Our ref: 5643

Land to the North of Sun Lane, Riseley

Wokingham Reference: 260774

Hart Reference: 26/00541/OUT

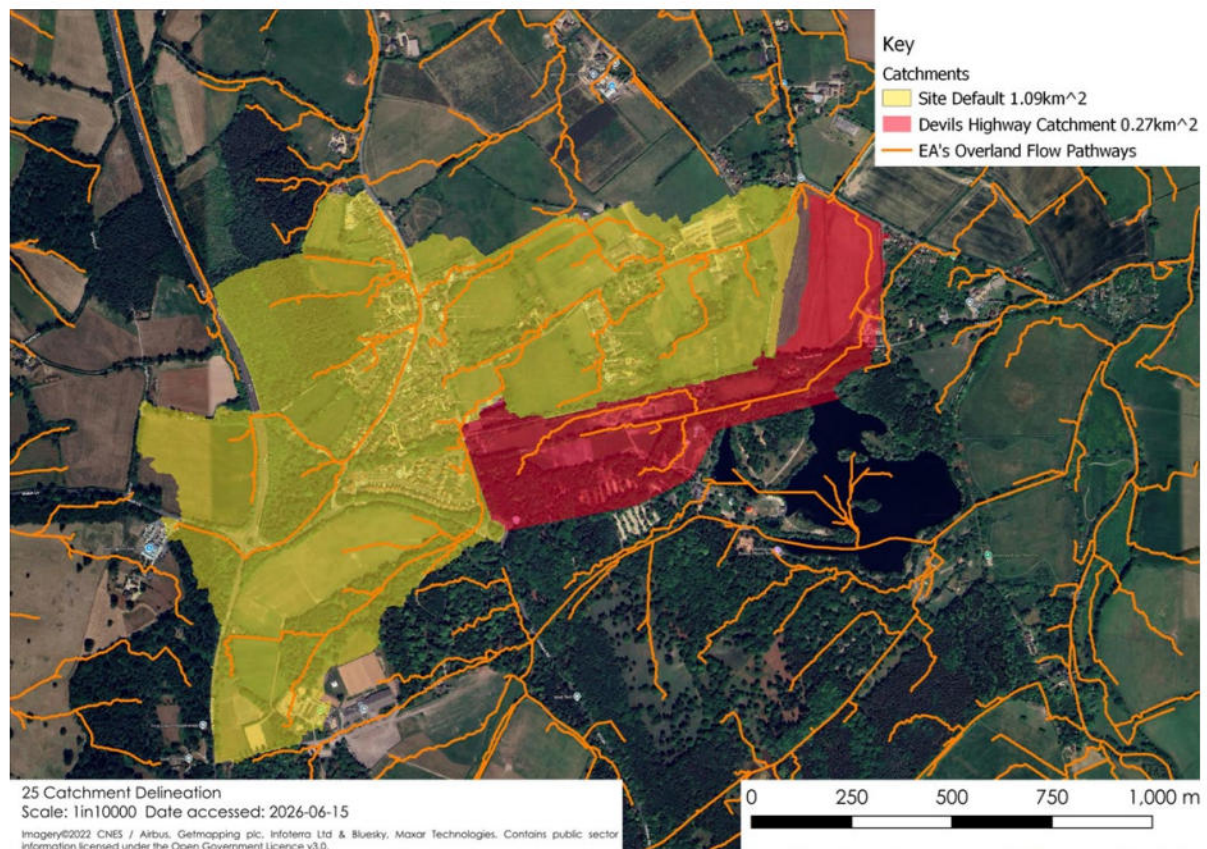
Drainage Outfall Location

Unfortunately, there is no existing ditch within or near the site to receive greenfield runoff. The only nearby ditch is located off-site to the north, however the site falls away from the ditch, which is located in third party land, meaning connectivity would rely on both pumping and riparian consent to discharge.

If you consider the existing site topography, any runoff generated by the site would pass through the adjacent downstream properties and would reach Basingstoke Road. We have undertaken a more detailed review of the wider catchment levels (using Lidar information) and found that Riseley comprises two primary watershed catchments – see below figure.

The site and the most of the urban extent of Riseley drain north, towards Riseley Green School, before flowing east towards Long River (hatched yellow). The alternative red hatched area represents land to the south, including the Wellington Country Park, which drains to a ditch adjacent the Devil's Highway. This ditch runs through mostly rural land and the country park, prior to discharging to Long River (at the same approximate location at the outfall route for the northern catchment). The red hatch catchment equates to 27.2ha, with a calculated greenfield runoff of 226 l/s.

We acknowledge that the proposed drainage route theoretically directs a new discharge to a separate catchment, however it should be considered that the site is reducing flows within the existing catchment which routes through/past urban developments and the school site by >10 l/s (whilst also offsetting future climate change). In contrast, it is only increasing flows through the Devil's Highway catchment by 3.8 l/s, from 226 l/s to 229.8 l/s. This equates to a proportional increase of just 1.65% increase (based on the existing drainage catchment, 27.2ha).

We would consider that any increase in risk posed by the proposed discharge arrangements are negligible and on balance, the proposals offer a greater amount of betterment within the developed extents of Riseley.
